TfNSW Reference: SYD22/00793/04

Council Reference: - DA22/1086 (Planning Portal Reference: CNR-48934)

**RE: CONSTRUCT MIXED USE DEVELOPMENT - MAYFAIR AT NORTH PENRITH
160-172 LORD SHEFFIELD CIRCUIT, PENRITH
CNR-48934 - DA22/1086**

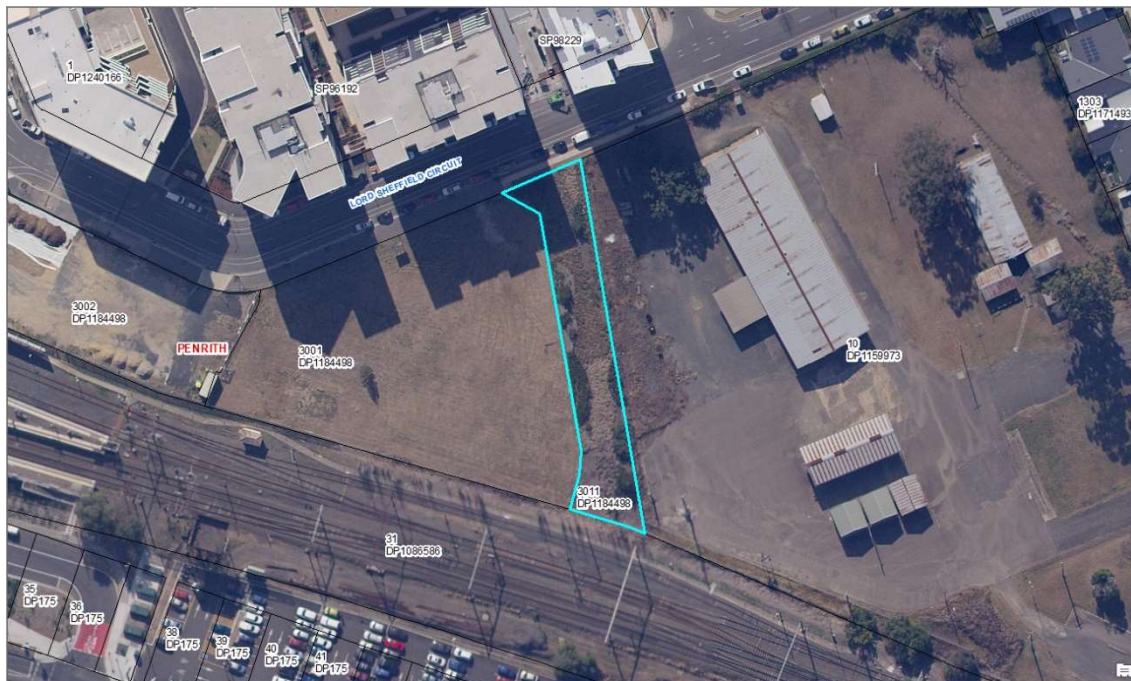
1. To enable an active transport connection to be provided in the future (subject to further with minimal demolition works, tree removal, community disruption etc. TfNSW require a 4m wide corridor, free of any landscaping or structures be provided within the easement. This path should be constructed as a paved path that runs parallel with the eastern boundary and will serve as the future active transport link between Lord Sheffield Cct and the future link across the rail line.

The easement will be provided in perpetuity for the benefit of TfNSW and subject to a Section 88B provision and to be provided at with no cost to TfNSW.
